RE: ESKOM EIA CONCERNS FOR THE PROPOSED NUCLEAR POWER STATION AND ASSOCIATED INFRASTRUCTURE (DEA Ref. No: 12/12/20/944)

RESPONSE TO SECOND DRAFT ENVIRONMENTAL IMPACT REPORT

THE COOLING SYSTEM

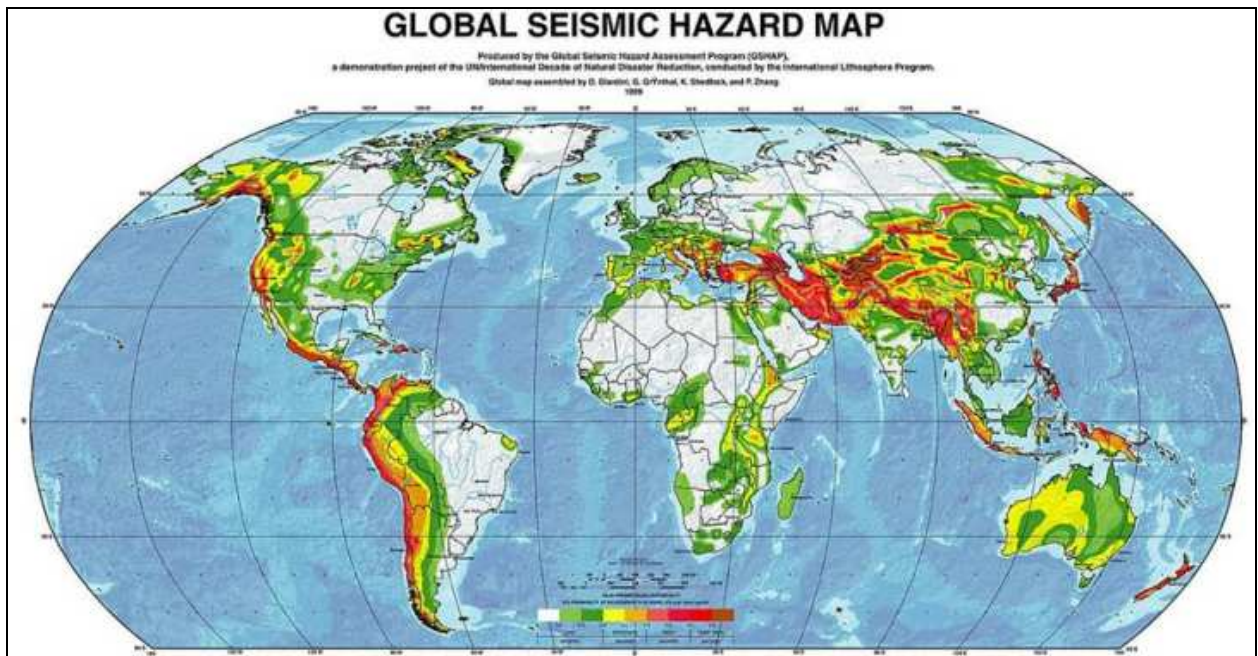
1. It is not clear how many tunnels are proposed. If it is to be only one, with one tower above the sea bed, can this legitimately be described as “defence in depth”?
2. What would happen if a blockage were to occur at the tunnel entrance?
3. Would Eskom be able to guarantee that this would not occur during the lifetime of the plant?
4. If not, would Eskom accept that this is a fatal flaw in the whole design concept?
5. In view of the evidence of major seismic activity across the globe, including a recent tremor at Plettenberg Bay, will any allowance be made for possible earth movement, and what impact could this have on concrete pipelines?

South Africa is seismically relatively stable, compared especially to Japan, which is situated on a major seismic subduction zone, where continental plates collide. The figure below illustrates the relatively low seismic risk in South Africa, compared to high risk zones such as the western coastlines of South America and North America, the Asia-Pacific Rim, most of South-Central Asia and the Middle East.

The worldwide, large seismic events referred to correspond to tectonic movements at plate boundaries. No such plate boundaries exist in South Africa. As the design basis seismic event for the Nuclear power plant represents one of the major load cases to be considered, seismic movement will be considered in all safety related structures. It should be noted that seismic movement corresponds to vibratory ground motion.

Lined tunnels and buried pipelines will accommodate seismic displacements along their length. As they are below ground structures they are not subject to the amplification effects experienced by buildings and as such are relatively robust against earthquakes.
